**ALERT SERVICE BULLETIN**

**SUBJECT: REVISION "B" TO ALERT SERVICE BULLETIN 407-03-57: (TAIL ROTOR GEARBOX CASE 406-040-406-109, /-113 OIL FEED HOLE FOR DUPLEX BEARING 406-040-432-103, ADDITION OF**

**NO.** 407-03-57

**SUBJECT:** TAIL ROTOR GEARBOX CASE 406-040-406-109, /113 OIL FEED HOLE FOR DUPLEX BEARING 406-040-432-103, ADDITION OF. **A**

**Figure 1. Location of the oil feed hole**

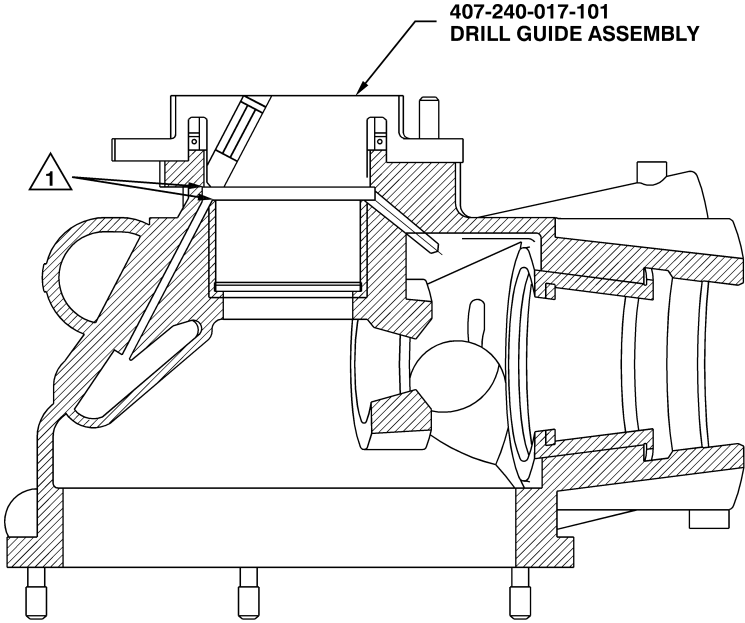
It has been determined that the oil feed gallery for duplex bearing 406-040-432-103 can be missing from the tail rotor gearbox case 406-040-406-109 and -113. Even though this duplex bearing is splash lubricated, this situation reduces the oil supply required to lubricate the duplex bearing 406-040-432-103 and can result in a bearing failure if not corrected.

5. Remove the pitch change mechanism (BHT-407-MM, Chapter 67).
6. Remove the duplex bearing outer race output nut (BHT-407-CR&O, Chapter 65).
7. Check if the tail rotor gearbox case has an oil feed gallery as shown in Figure 1 of this bulletin.
  - a. If the case has an oil feed gallery, this bulletin is completed, continue with Step 8 below. Use a vibrating stylus and re-identify the case assembly as follows:

Tail rotor gearbox cases 406-040-406-109 and 406-040-406-113 are affected by this bulletin.

- b. If the oil feed gallery is missing from the case, do PART II of the ACCOMPLISHMENT INSTRUCTIONS within the compliance time.
8. Install the output duplex bearing outer race nut (BHT-407-CR&O, Chapter 65).

**Figure 2. Rework of the tail rotor gearbox case**

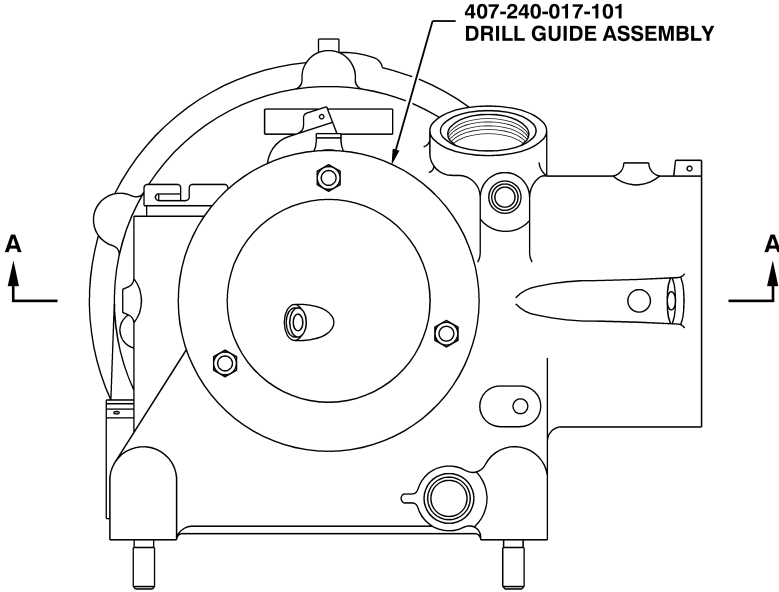
3. Clean the gearbox case. Make sure that paint or sealant is fully removed from the gearbox surface that contacts with the drill guide.
4. Install the drill guide tool 407-240-017-101 on the gearbox case assembly and attach with the existing hardware (Figure 2).

5. Position and set a drill stop  $4.50 \pm 0.030$  inches ( $114.3 \pm 0.76$  mm) from the point of a short fluted twist drill bit. Lubricate drill with cutting oil and drill the oil feed gallery in the gearbox case.

Duplex bearing liner can be nicked as the gallery is drilled.  
This is not detrimental to the liner. Use a Swiss file and remove sharp edges.

6. Remove the drill guide tool 407-240-017-101.
7. De-burr the sharp edges of the hole.
8. Fully clean the gearbox case. Make sure that no unwanted material stays in the cavities.

9. Apply Corrosion Preventive (DOW #19) (C-103) to reworked area (BHT-ALL-SPM, Chapter 3).
